Elevation line at new  
wall height ( 4.7 ft)

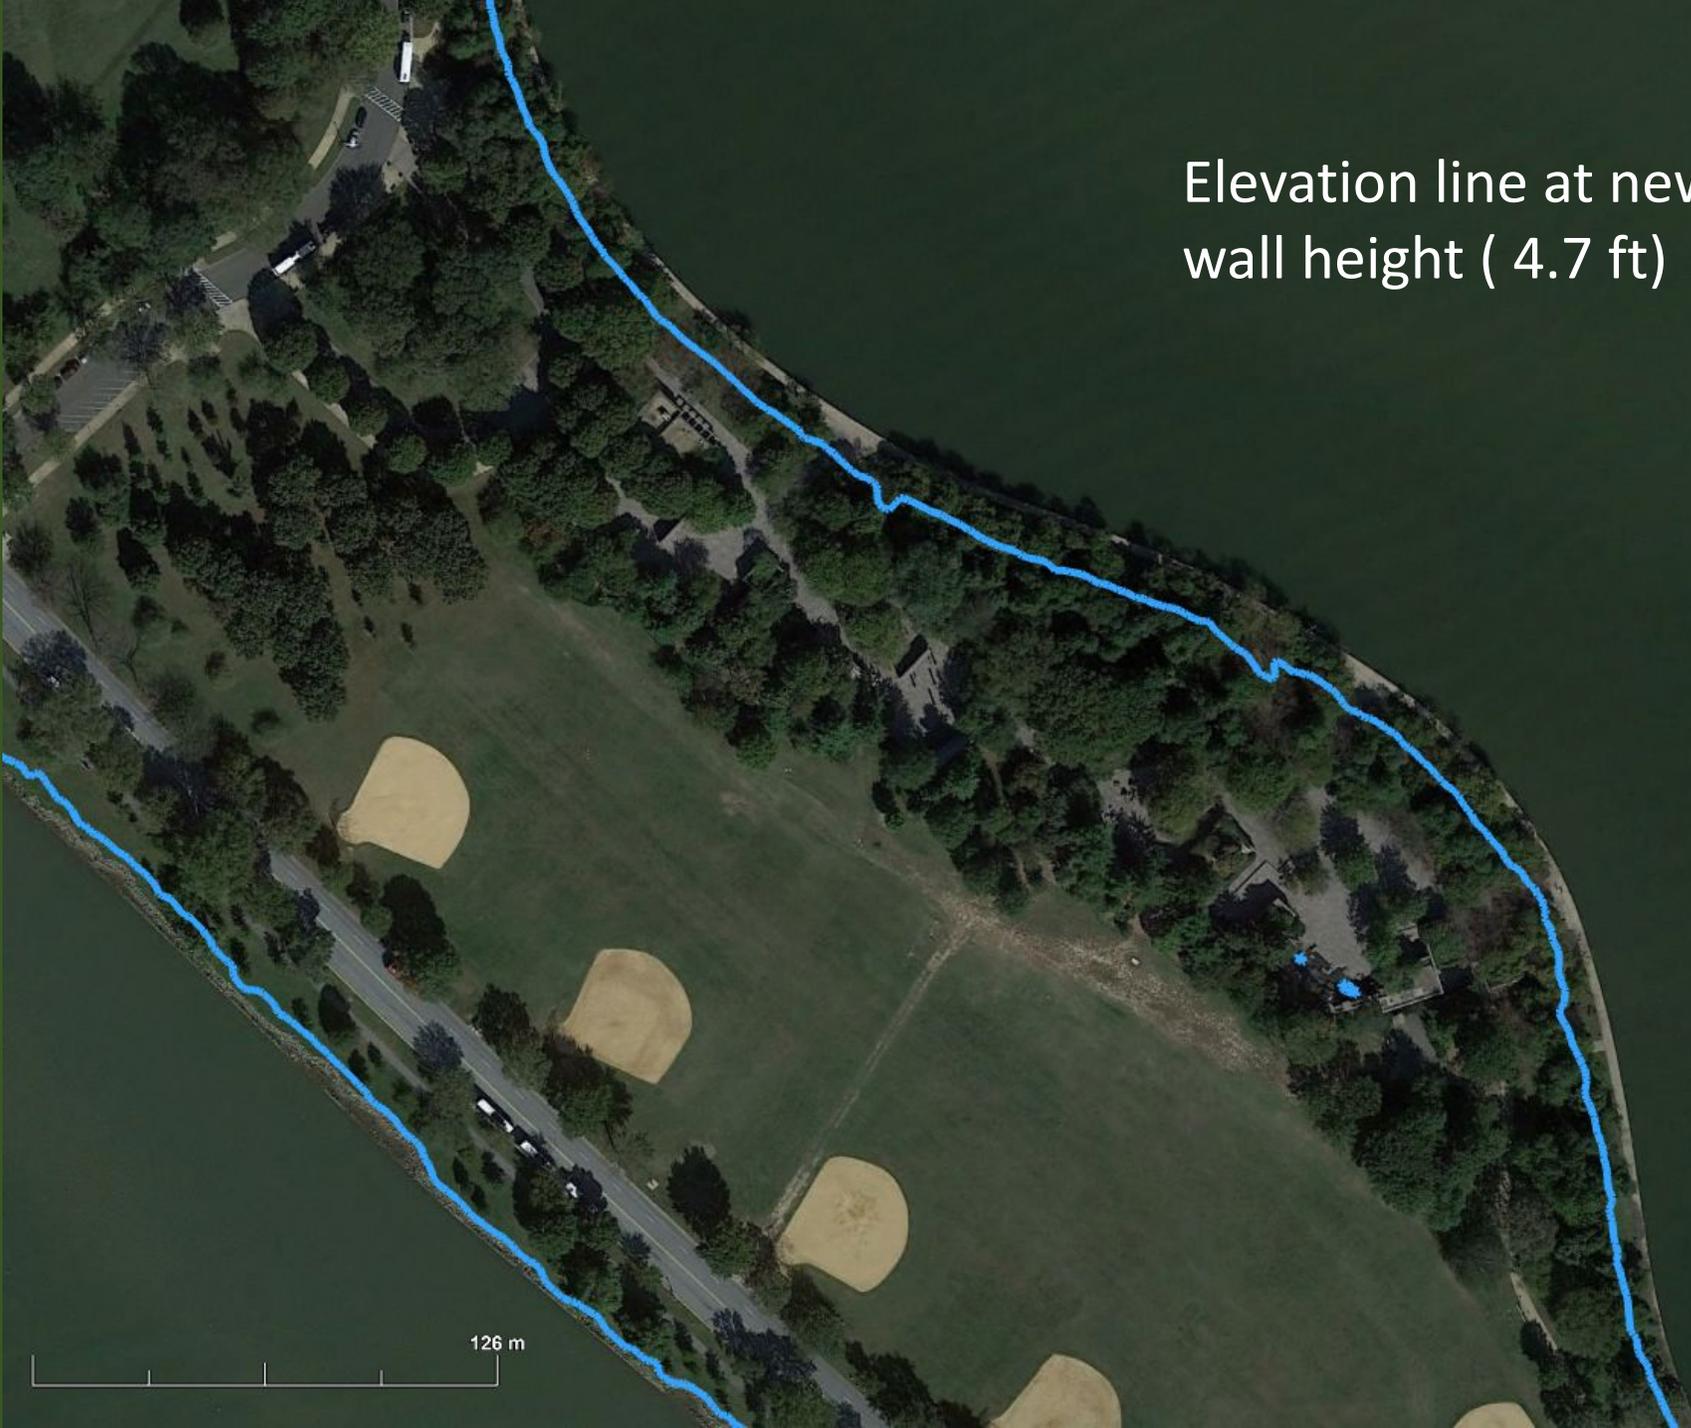
4. The plan will ***fall short in protecting the path along the shore to the FDR memorial.***
5. An adequate plan should ***define the frequency of flooding that is tolerable.*** Perhaps once every 10 or 20 years would be appropriate.

7. An assessment should be conducted of ***storm water management.***
8. A reliable calculation is needed on the ***potential for exacerbated flooding at FDR and MLK memorials.***

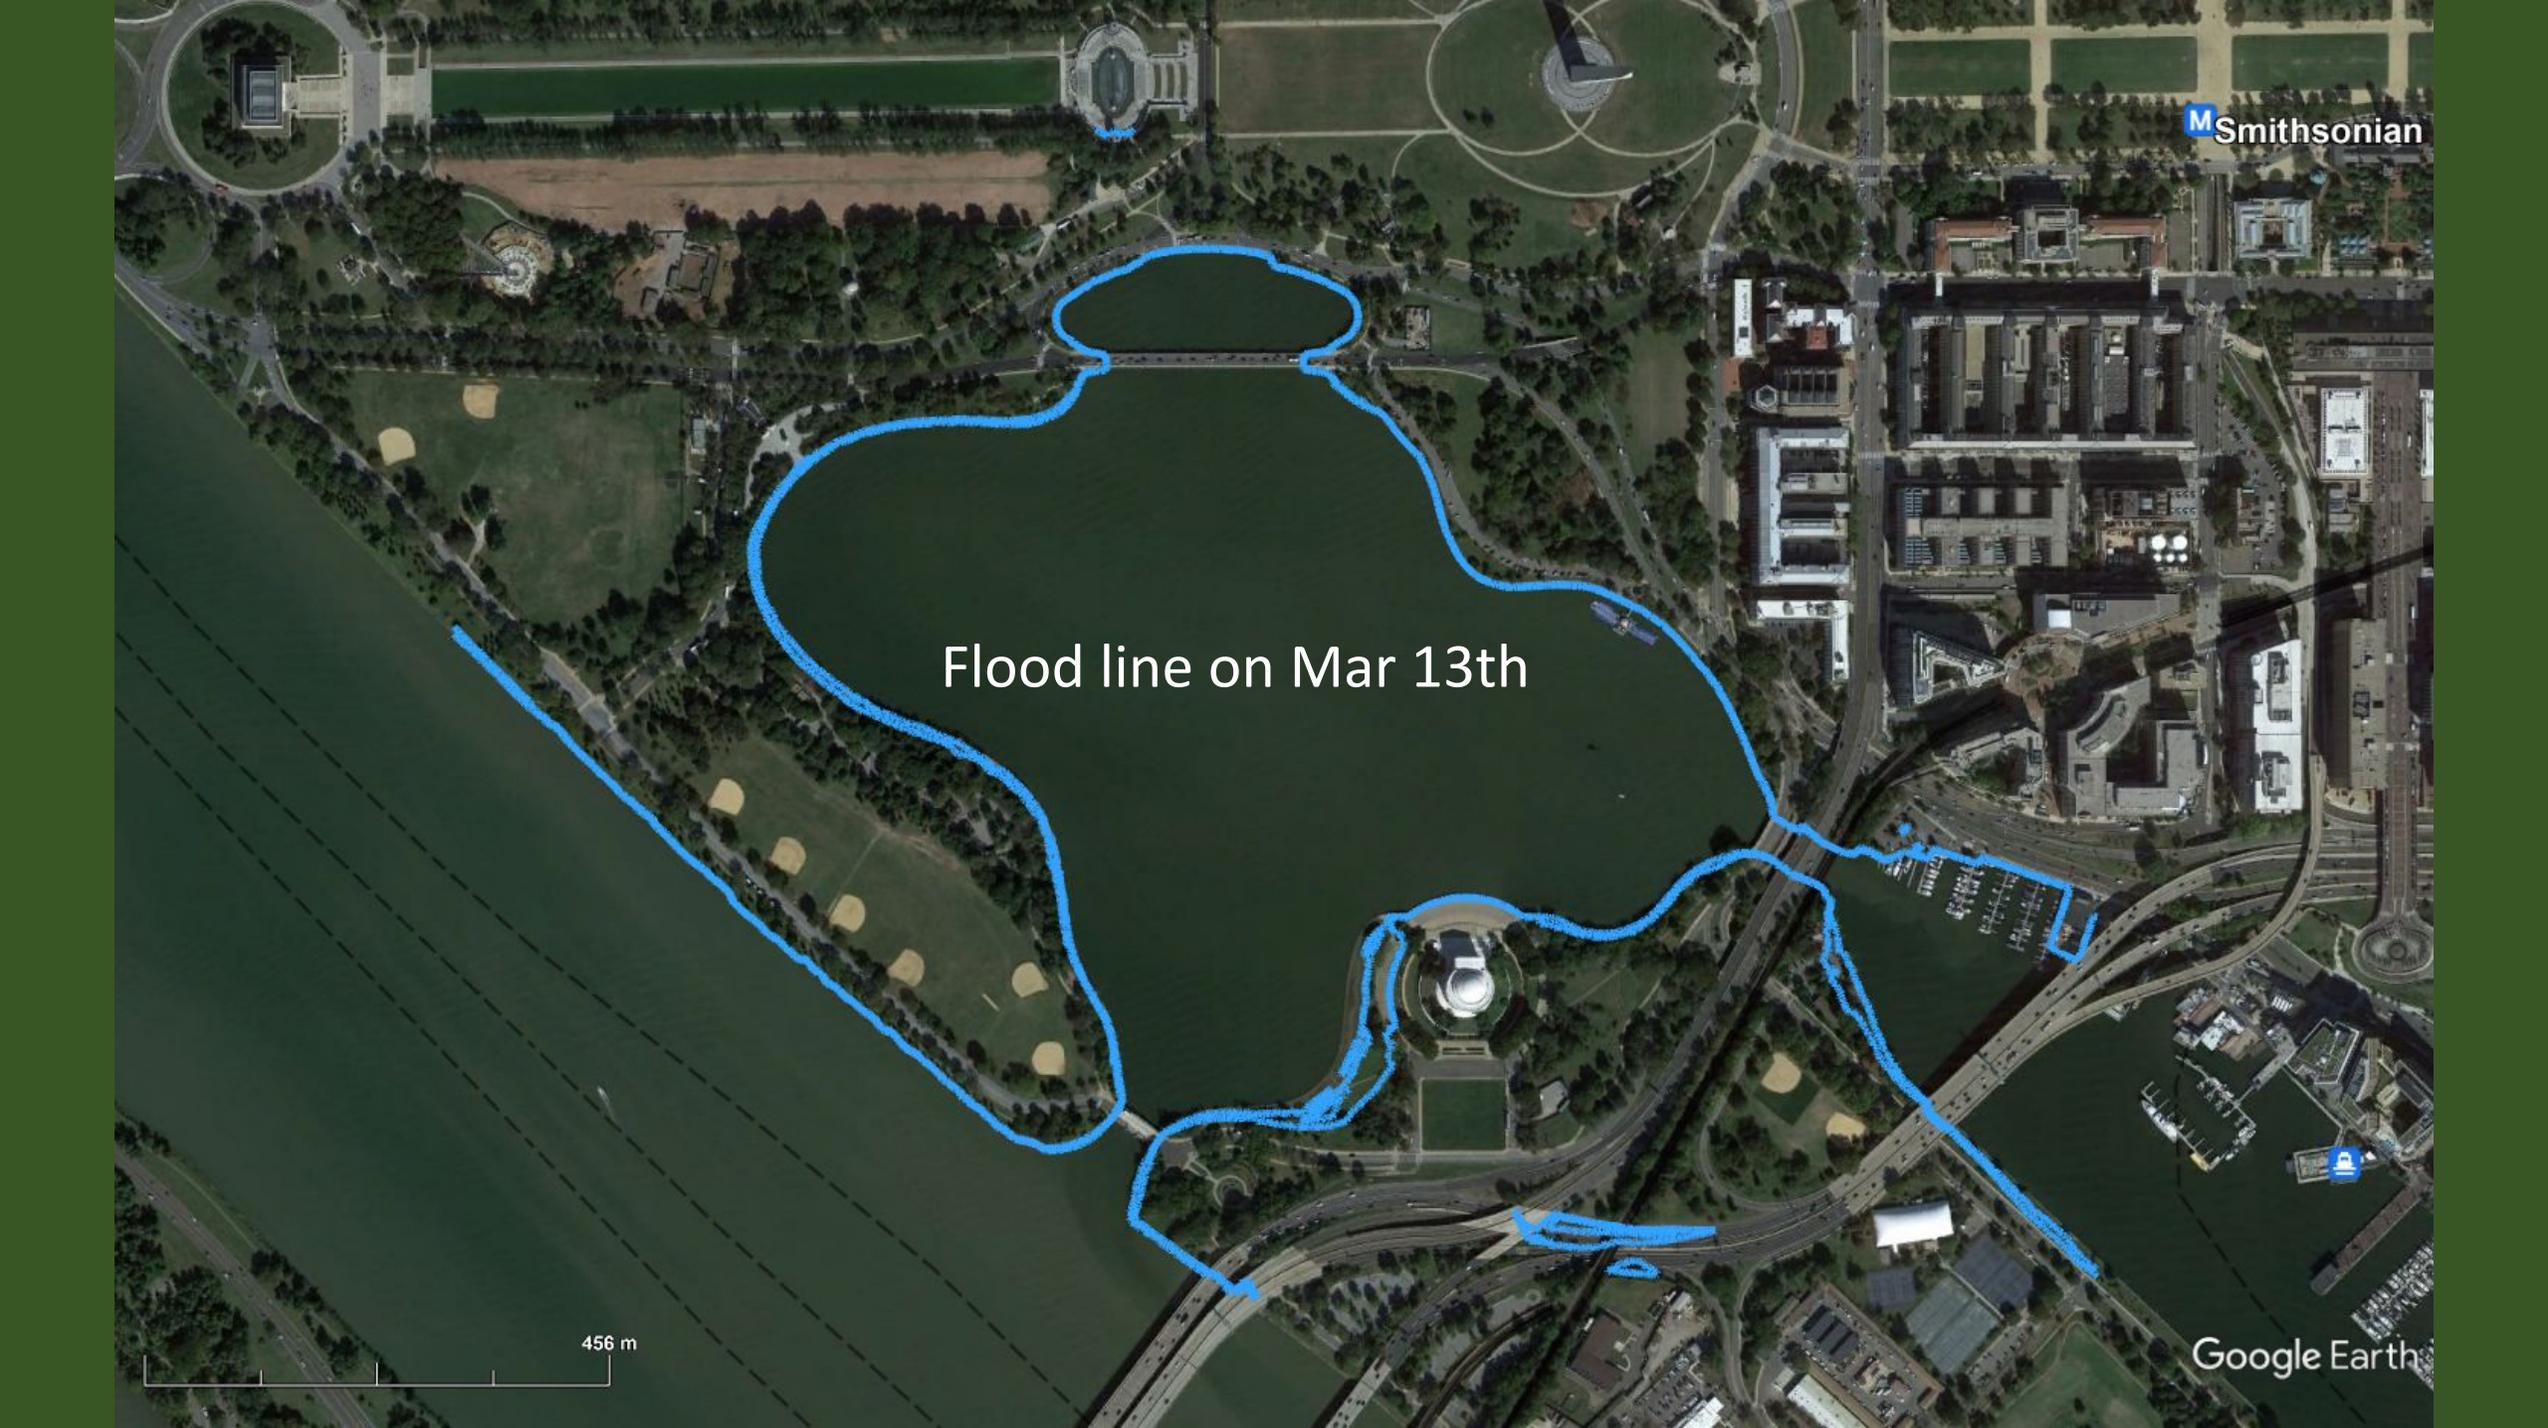
1. A robust quantitative assessment is needed on the potential effects of the project's new coastal morphology on ***the compound flooding*** from co-occurring storm surges and rainfall.

2. A reliable quantitative assessment is needed on the potential ***effects of sea-level rise*** around the tidal basin under the new coastal geometry. A plan of this scope and extent should have a planning horizon of 30 to 50 years.
